Work Order ID 94353

Item Name: Crosstube Turning Detail

DART AEROSPACE LTD	Work Order:	94353
Description: Crosstube Assembly (205/212/412 High Fwd)	Part Number:	D212-664-141
Inspection Dwg: D212-664-141 Rev: D		Page 1 of 2

DRAWING NO. D212-664-141	TITLE XTUBE ASSY (205/212/412 HI FWD)	REV. D	DART AEROSPACE LTD ENGINEERING ORDER		D.E.O. NO. D212-664-141-D-1	SHEET NO. SHEET 1 OF 2	SCALE NTS
DRAWN	CHECKED <i>AP</i>	MFG. APPR. <i>R</i>	APPROVED <i>MP</i>	DE APPR. <i>MP</i>			
DATE 11.04.07	DATE 11.07.11	DATE 11.04.12	DATE 11/04/12	DATE 11.04.12

D212-664-141/-141B
ASSEMBLY DETAIL

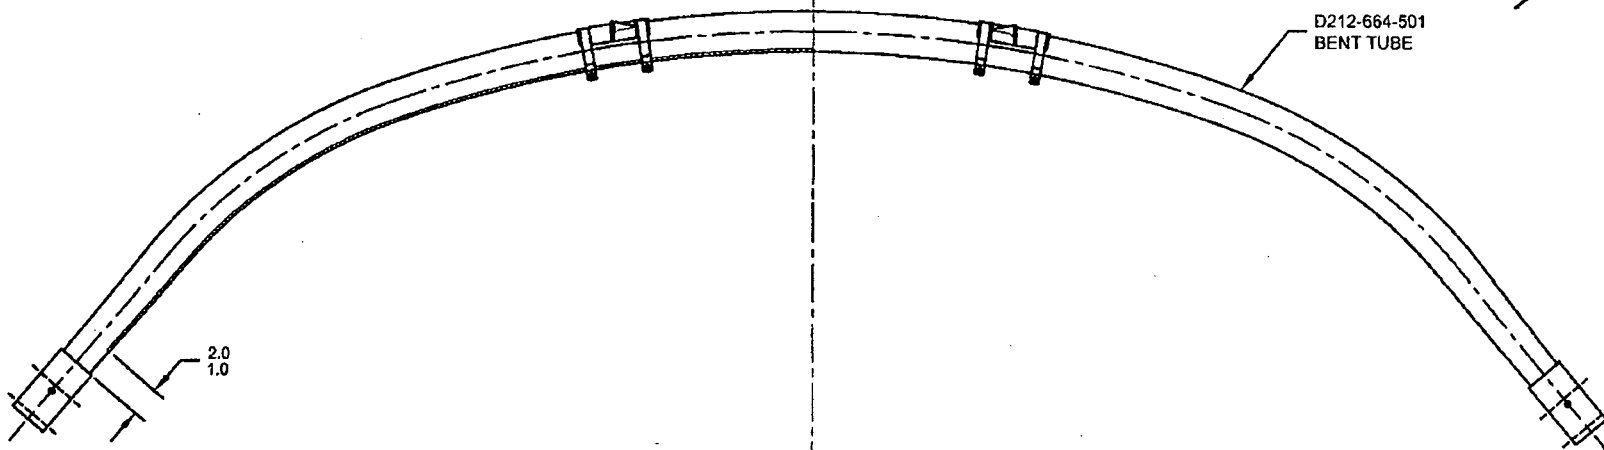
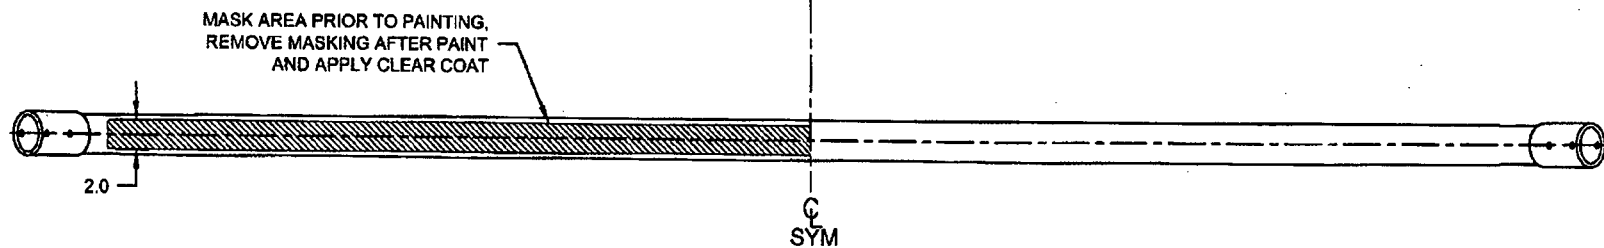
PURPOSE:

ADD AN INSPECTION WINDOW TO UNDERSIDE OF CROSSTUBE.

CHANGE:

NOTES 2 OF SHEET 1 IS AMENDED AS FOLLOWS:

- 2) FINISH: CHEMICAL CONVERSION COAT PER DART QSI 005 4.1
PRIME INSIDE AND OUTSIDE PER DART QSI 005 4.2
MASK UNDERSIDE OF CROSSTUBE AS SHOWN (HATCHED AREA) AND
PAINT OUTSIDE PER DART QSI 005 4.2
REMOVE MASKING AND APPLY CLEAR COAT
